<b>STATE OF VERMONT AGENCY OF TRANSPORTATION</b>			
Town Of	MILTON	Bridge No.	81N & 81S
Highway No.	189	Log Sta.	MM 1066.30
		Surv. Sta.	---
<b>189 OVER THE LAMOILLE RIVER</b>			
<b>ADDITIONAL CRACK LOCATIONS</b>			
Designed By	P.M. THURBER	Drawn By	P.M. THURBER
Checked By	J.B. MCCARTHY	Bridge Design Supervisor	J.B. MCCARTHY
Date	04/1999	Date	04/1999
PROJECT	MILTON	PROJECT NO.	IM 089-3(31)
Bridge Sheet No.		Sheet	7 of 7

NEW CRACK LOCATIONS

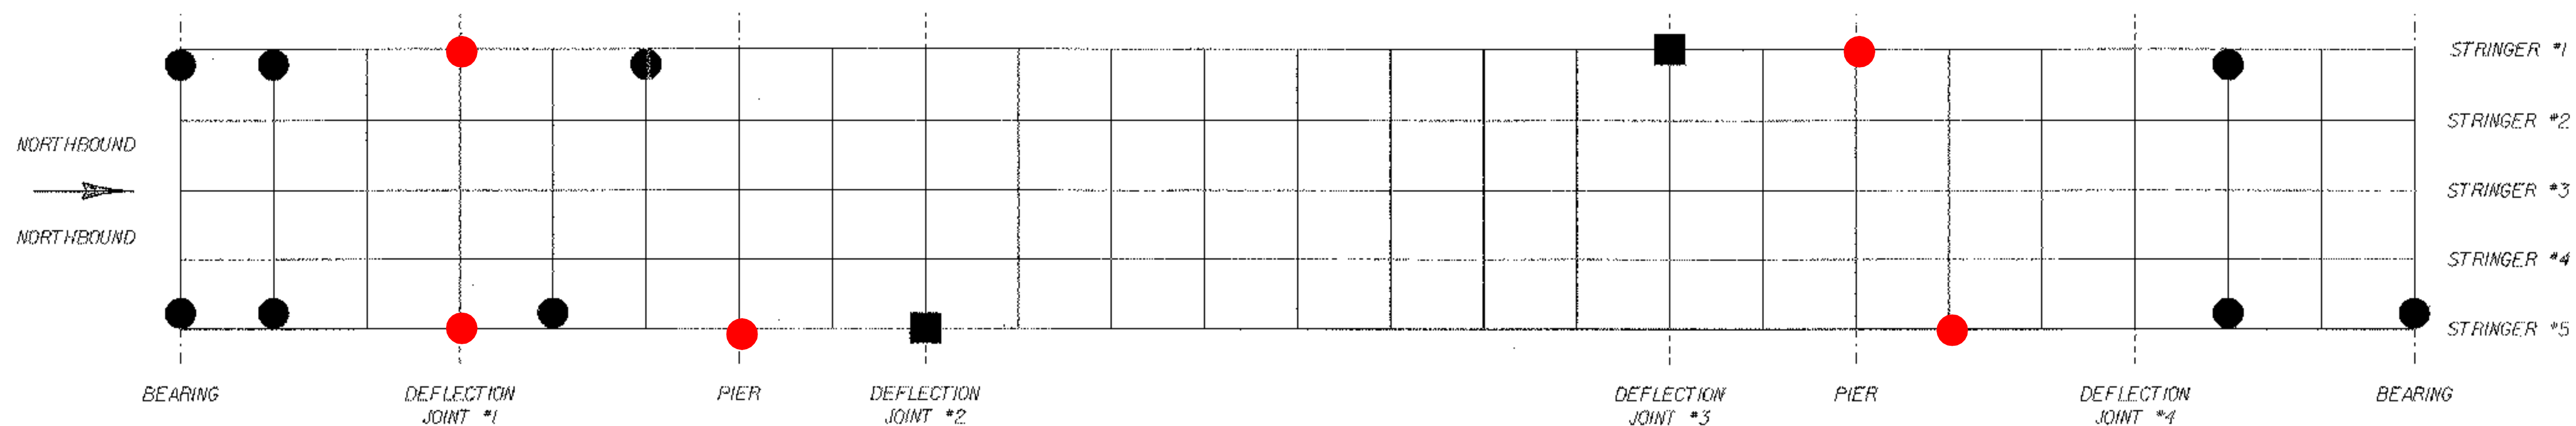
ALL CRACKS IN THE EXISTING STRUCTURAL STEEL AT LOCATIONS INDICATED IN THESE PLANS SHALL BE REPAIRED PRIOR TO ADDITION OF THE ANGLES AND CHANNEL DIAPHRAGMS. ALL CRACKS SHALL BE REPAIRED USING AN APPROVED GROOVE WELD PROCEDURE. PAYMENT FOR CRACK REPAIR SHALL BE MADE UNDER ITEM 506.75 "STRUCTURAL STEEL (MODIFIED)".

PRIOR TO PERFORMING ANY FIELD WELDING, THE CONTRACTOR SHALL HAVE AN APPROVED REPAIR PROCEDURE. THE CONTRACTOR SHALL SUBMIT FOR APPROVAL DETAILS AND WELDING PROCEDURES IN CONFORMANCE WITH SUBSECTION 105.03 AND 506.04 OF THE VERMONT AGENCY OF TRANSPORTATION SPECIFICATIONS TO THE STRUCTURES SECTION.

PRIOR TO BEGINNING WORK, THE CONTRACTOR SHALL ARRANGE FOR A FIELD INSPECTION OF THE STRUCTURES. A VDOT BRIDGE INSPECTION TEAM, RESIDENT ENGINEER, CONTRACTOR AND ANY SUB-CONTRACTORS INVOLVED IN THE REPAIR OF THE STRUCTURAL STEEL SHALL BE PRESENT AT THIS FIELD INSPECTION. THE PURPOSE OF THE FIELD INSPECTION IS TO SUPPLEMENT THE PLANS IN REGARDS TO THE CRACK LOCATIONS.
